# UNITED STATES PATENT AND TRADEMARK OFFICE

APPLICATION NO.	FILING DATE	FIRST NAMED INVENTOR	ATTORNEY DOCKET NO.	CONFIRMATION NO.
10/583,550	05/21/2007	Giovanni Stefani	292784US6PCT	9838
22850 7590 05/29/2009 OBLON, SPIVAK, MCCLELLAND MAIER & NEUSTADT, P.C. 1940 DUKE STREET ALEXANDRIA, VA 22314				
EXAMINER MURPHY, TIMOTHY J				
ART UNIT 3656		PAPER NUMBER		
NOTIFICATION DATE 05/29/2009		DELIVERY MODE ELECTRONIC

### Office Action Summary

## DETAILED ACTION

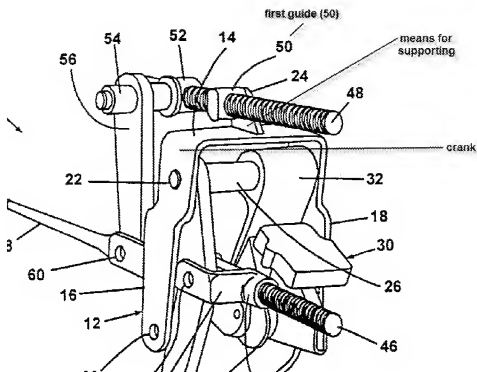
**Regarding claim 18**, Brock discloses an adjustable set of pedals for a motor vehicle, comprising:

- a first pedal (36 and 38; fig 1) for braking of the motor vehicle;
- a second pedal (31; 34; fig 1) for acceleration of the motor vehicle;
- means for supporting the first and second pedals (see figure below); and

- an adjustment device (fig 1 shows adjustment device for pedals 36, 31) for controlling selectively the position of the supporting means with respect to a frame of the motor vehicle (104; fig 8) and comprising a crank mechanism (cradle 12 acts as a crank between nut 50 and pin 26) set between the supporting means and the frame (fig 8);

- the adjustment device comprising:
  - a first guide (nut 50) extending in a first direction (along 48) and supporting the supporting means (via ear 24) which are mobile along the first guide; and

- a control rod (second ball screw 46 and nut 42) parallel to the first direction, slidably engaged through the first pedal (via 42), and connectable with the first pedal for actuating a braking device of the motor vehicle (via elements 42 and push rod 58)

- wherein the first guide (50) is fixed to the frame and the supporting means are mobile along a rectilinear path (means for supporting are mobile along 48, which is a straight line).
